Staff Analysis

Expanded Overview:

The requested conditional rezoning by Sand Dollar Homes contains a +/- 27.287-acre parcel of land currently zoned RA (Residential Agricultural to R-20SF see **(Figure 1)**). The rezoning request is consistent with the R-20 SF cluster development and is consistent with all Unified Development Ordinance requirements. The requested rezoning is consistent with the Swansgate subdivision zoned R-20 Cluster, the Oyster Bay subdivision across Swansboro Loop Road zoned R-10 and the other R-10 subdivisions in the area.

Figure 2- Future Land Use Map

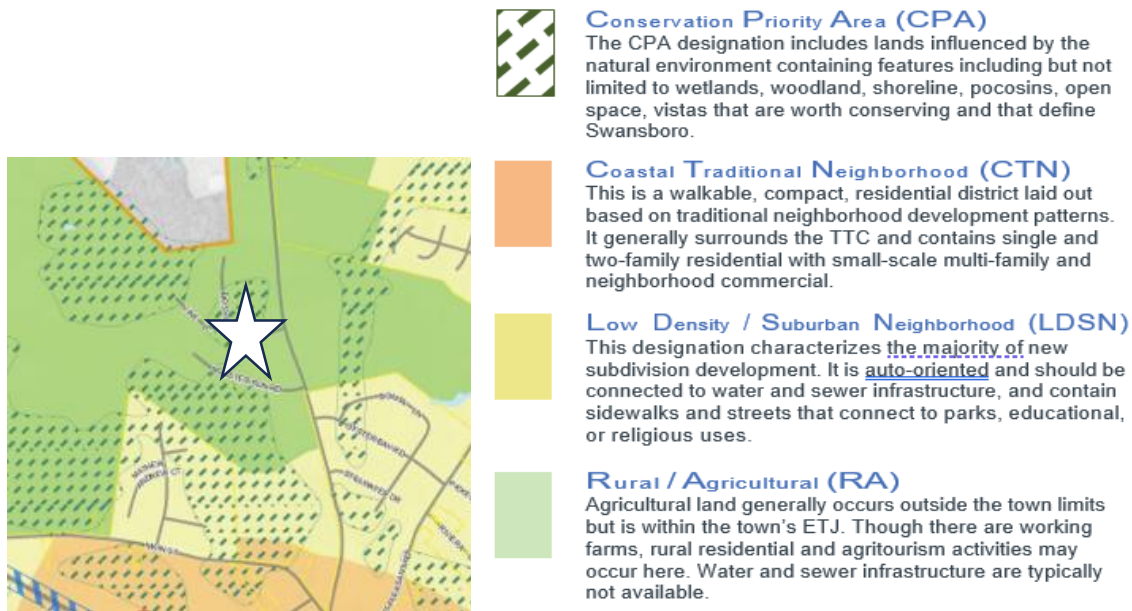
The CAMA Land Use Plan Future Land Use Map depicts this parcel as Rural/Agricultural and CPA (Conservation Priority Area). The Conservation Priority Area is because of the wetlands located on the site. Please see **(Figure 2)**. On August 28, 2023, an amendment to the CAMA Land Use Plan Update changed the analysis on pages A-29 and A-30 from protection of only isolated wetlands to protection of all environmentally sensitive areas. Further, the amendment included isolated wetlands in the definition of environmentally sensitive areas and protects wetlands when development is proposed with zoning incentives such as cluster development. Find the link below:
